<p>4. ZONING BY-LAW AMENDMENT – 667 BANK STREET</p> <p>MODIFICATION AU RÈGLEMENT DE ZONAGE – 667, RUE BANK</p>
--

Ward: CAPITAL (17) / CAPITALE (17) File Number: ACS2017-PIE-PS-0133

SUBJECT: Zoning By-law Amendment – 667 Bank Street

Document 3 – Schedule: Maximum Permitted Building Height

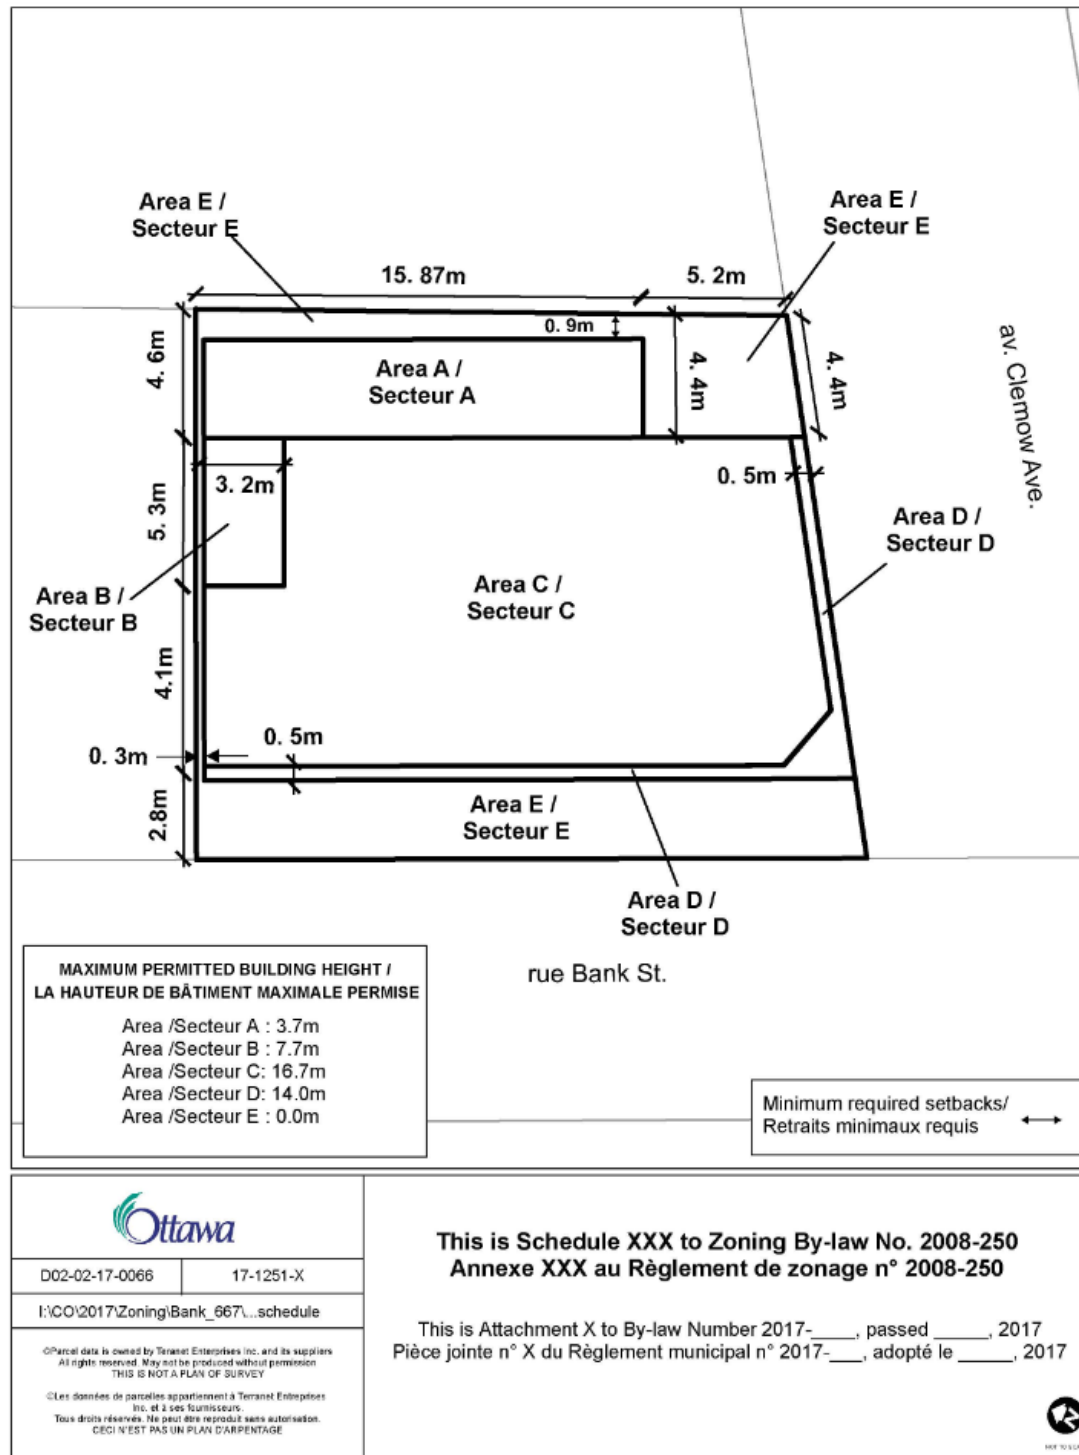
Rear lot line building setbacks and respect for the 45-degree angular plane above 15 metres

It does not come close to meeting the requirement for a 7.5-metre setback. And even taking into account some relief from the setback requirement, there is no respect for a 45-degree angular plane that is intended to provide appropriate transition.

This proposal needs to be amended, with increased setbacks, to achieve better transition to the rear as is intended by the Official Plan.

The schedule in Document 3 outlines the site-specific height permissions being sought. The TM zone requires that buildings step back above the fourth floor (or 15 metres) at a 45-degree angular plane. This building cannot meet this requirement because of the elevator and staircase locations. However, as the building is only 1.7 metres higher than the permitted 15 metres, the impacts of this are minimal. Sun shadowing impacts are almost indistinguishable. Overlook is also minimized as the units are oriented to face mainly west to Bank Street and south to Clemow Avenue. The impact to the abutting dwelling of a 6-metre high accessory structure (as permitted by the as-of-right zoning) within the rear yard would be greater than the proposed building with its incremental heights.

Planning staff are of the opinion that the 16.7-metre height is an appropriate scale for the intersection of Bank Street (which has a right-of-way width of 18 metres) and Clemow Avenue (which has a right-of-way width of 26 metres) and that the proposed five-storey, 16.7-metre building achieves a compatible fit on a lot where there are sensitivities or constraints on all sides. The overall composition of the building is balanced, and, given the lot size, a variety of approaches beyond the setbacks and
